MAINE TURNPIKE AUTHORITY

ADDENDUM NO. 2

CONTRACT
2020.03

PORTLAND AREA WIDENING &
SAFETY IMPROVEMENTS
MILE 43.0 TO MILE 46.4

CLIENT: UNITIL
PROJECT: MTA GRANITE STATE HDD
Title: MTA JACK & BORE CROSSING SOUTH PORTLAND, ME
PLAN VIEW - OVERVIEW

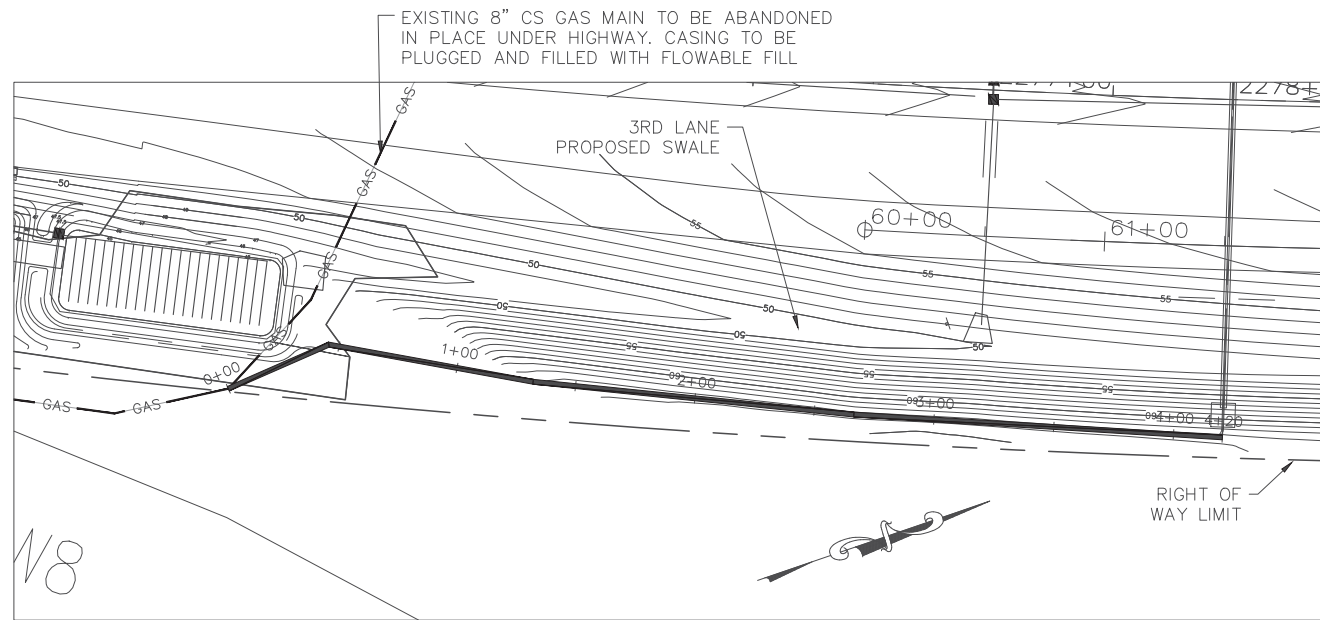
- Special Provision 104.4.6 Utility Coordination
 - Special Provision page SP-11, Granite State Gas/Unitil section, is updated to include three plan sheets showing a 50% complete design of the proposed gas line replacement; pages numbered SP-11A, SP-11B, and SP-11C.

PORTLAND AREA WIDENING & SAFETY IMPROVEMENTS
 MM 43.0 TO MM 46.4
 TYPICAL SECTIONS (1 OF 3)

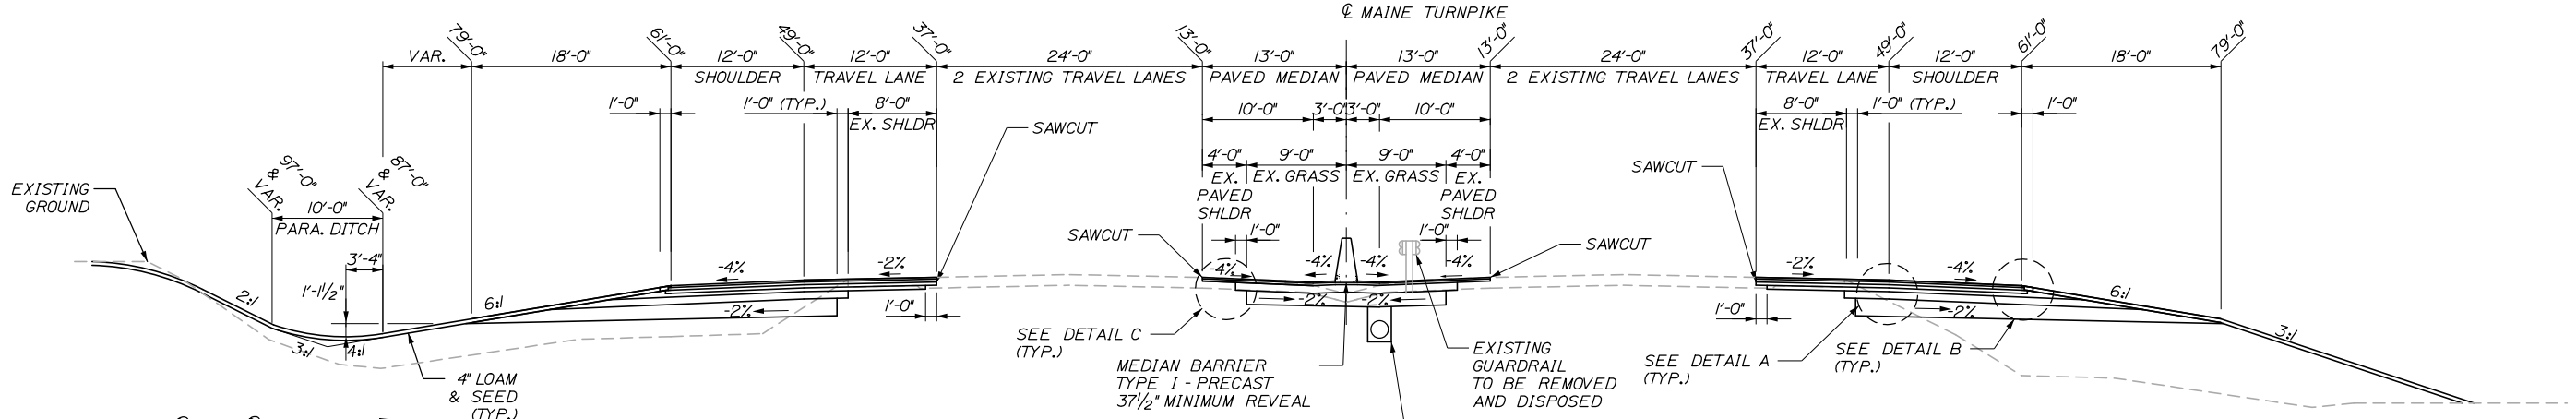
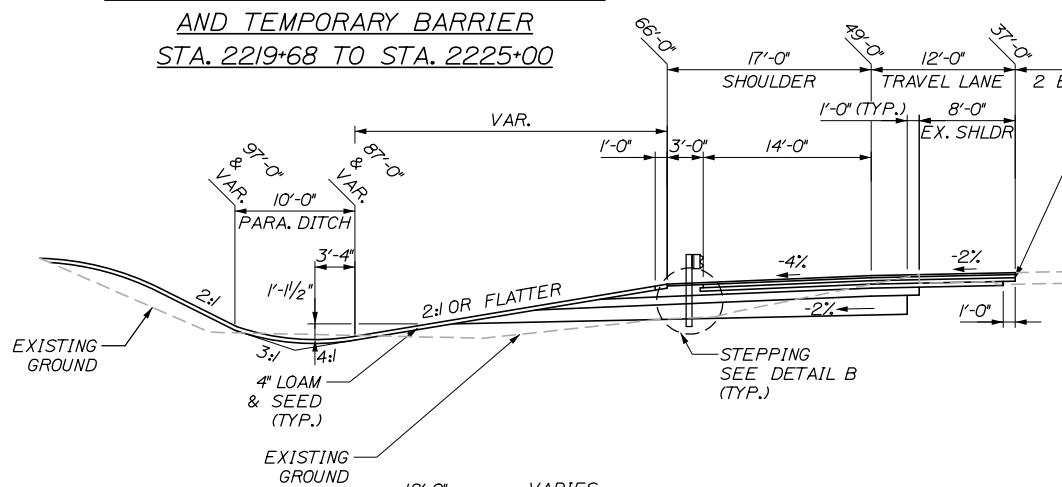
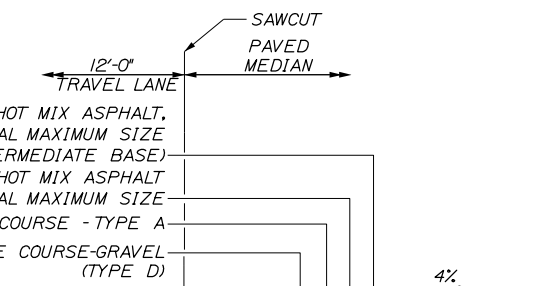
- Special Provision 403
 - Special Provision 403 Hot Mix Asphalt Pavement Table and Complimentary Note callouts are deleted and replaced. See Attached. Revisions relative to adding changing HMA type for median construction and the use of material transfer vehicle.

Question 8: Are the median shoulders meant to be surfaced with the Polymer Modified HMA?

Answer: Special Provision 403 is deleted and replaced to change the median pavement to 403.213 HMA and to remove the requirement of a material transfer vehicle for the median paving.

PORTLAND AREA WIDENING & SAFETY IMPROVEMENTS
MM 43.0 TO MM 46.4
GUARDRAIL DETAILS
MIDWAY SPLICE

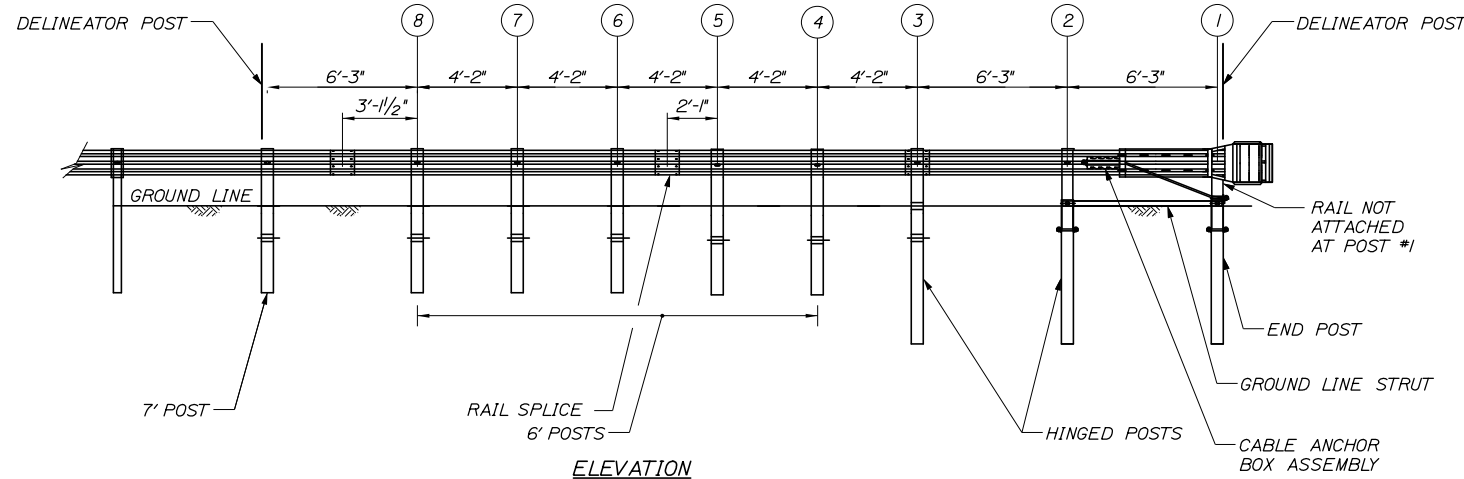
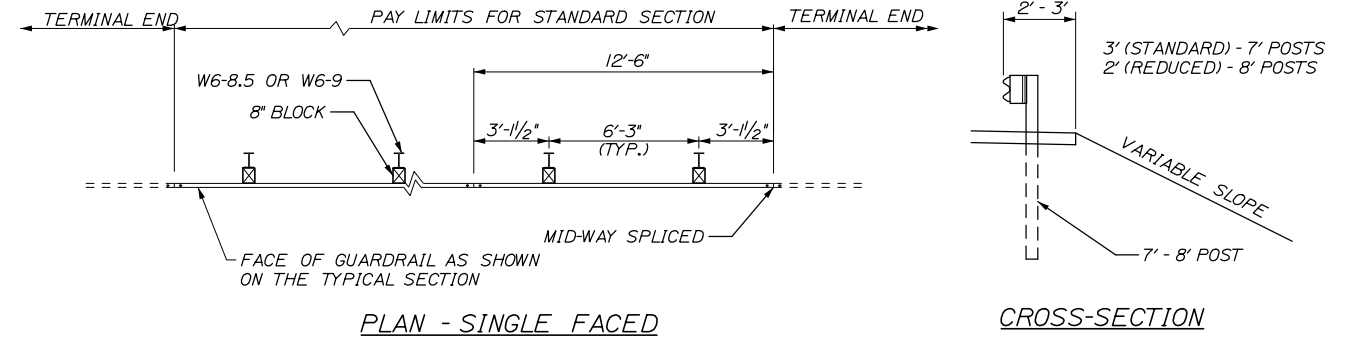
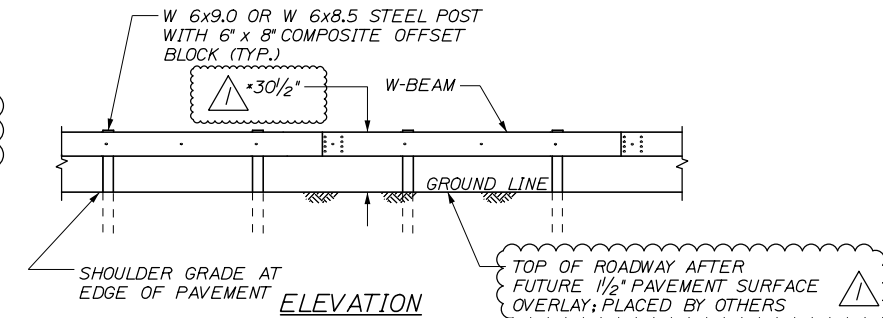
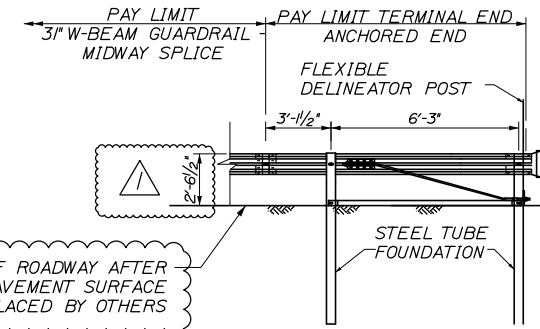
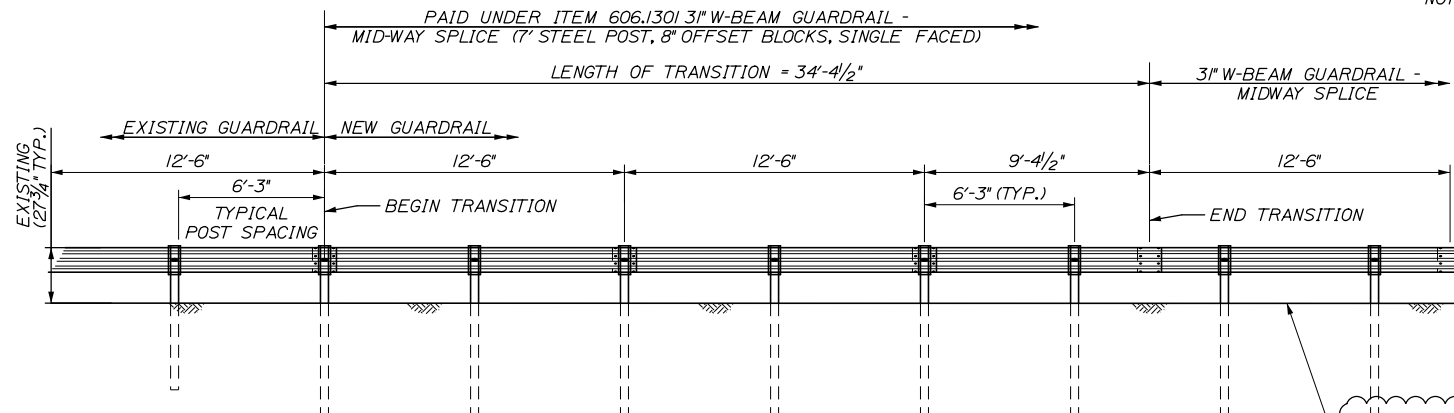
Scale: NOT TO SCALE			
No.	Revision	By	Date
1	Clarify Road Surface and Guardrail Height		3/20

*MEASURED FROM FUTURE 1/2" PAVEMENT SURFACE OVERLAY; PLACED BY OTHERS

MEDIAN GUARDRAIL TRANSITION DETAIL

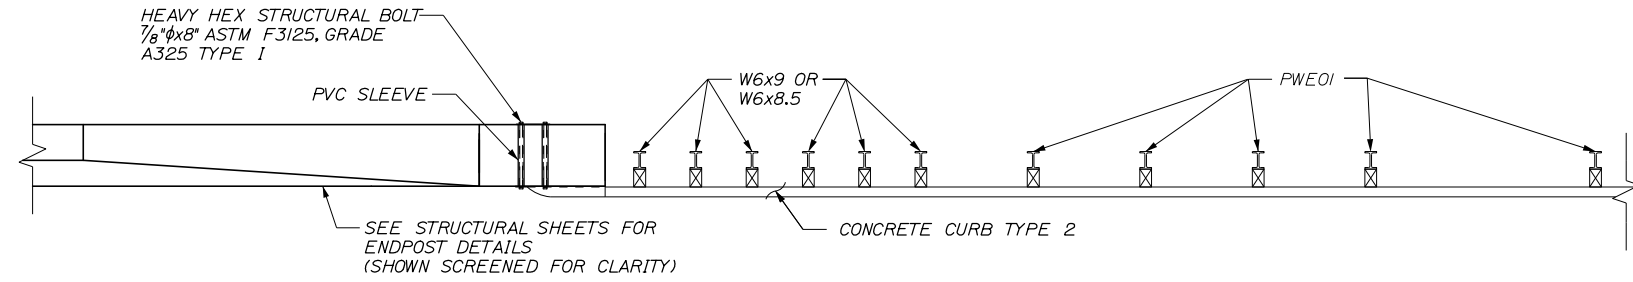
No.	Revision	By	Date
1	REVISED GUARDRAIL HEIGHT	BRG	03/20

EARTH RETAINING BARRIER GUARDRAIL TRANSITION DETAILS

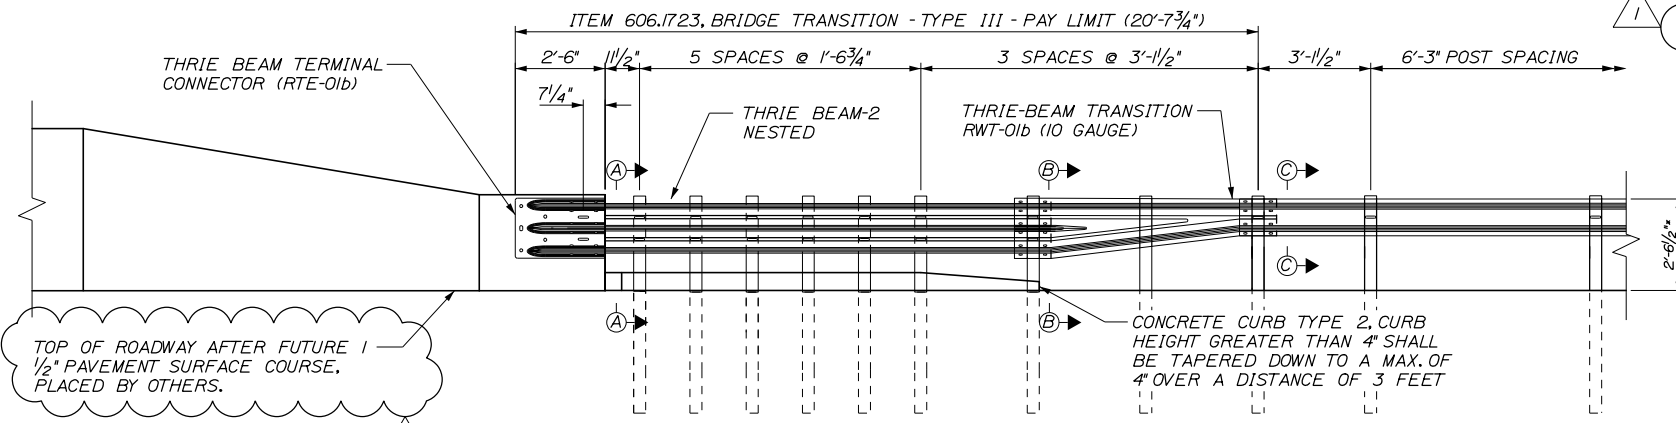
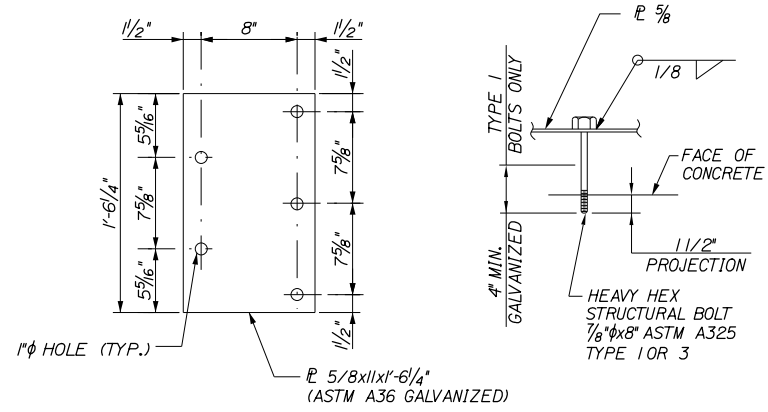
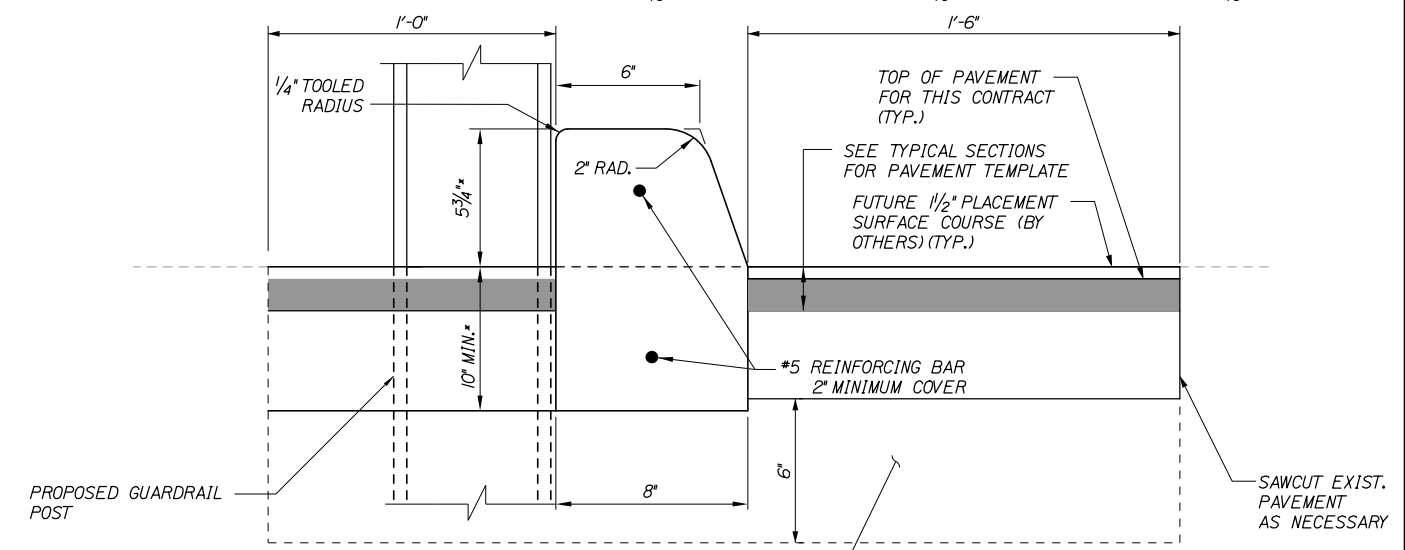
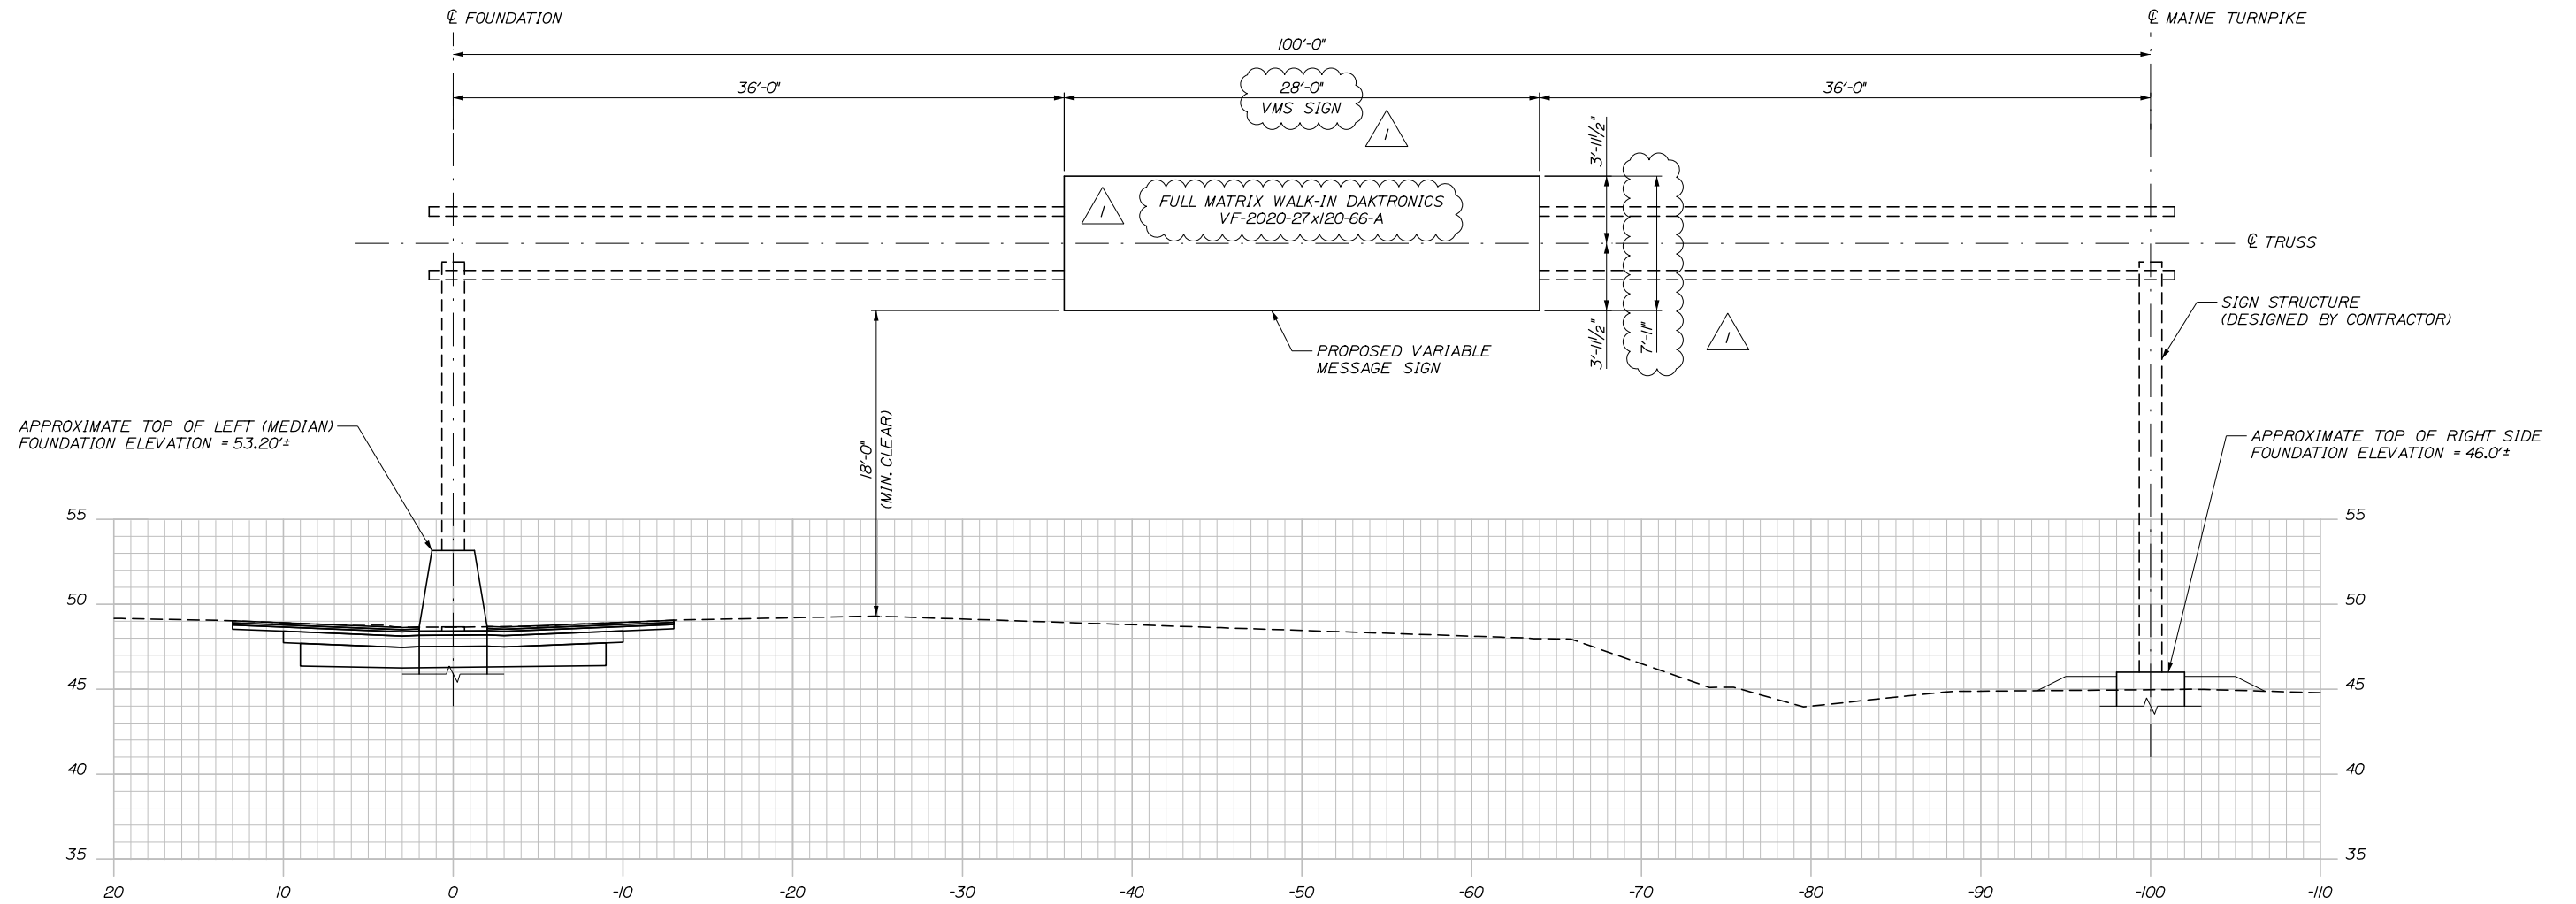
No.	Revision	By	Date
1	REVISED GUARDRAIL HEIGHT	BRG	03/20

- 1" HOLE IN CONCRETE SHALL BE FORMED BY A METHOD APPROVED BY THE ENGINEER.
 - GUARDRAIL HEIGHT SHALL BE ADJUSTED UNIFORMLY BETWEEN SECTION CALLOUTS.
 - TOP OF GUARDRAIL HEIGHT SHALL BE 32" ABOVE THIS CONTRACT'S PAVEMENT SURFACE. THIS WILL RESULT IN A HEIGHT OF 30 1/2" ABOVE A FUTURE 1/2" OVERLAY, INSTALLED BY OTHERS.
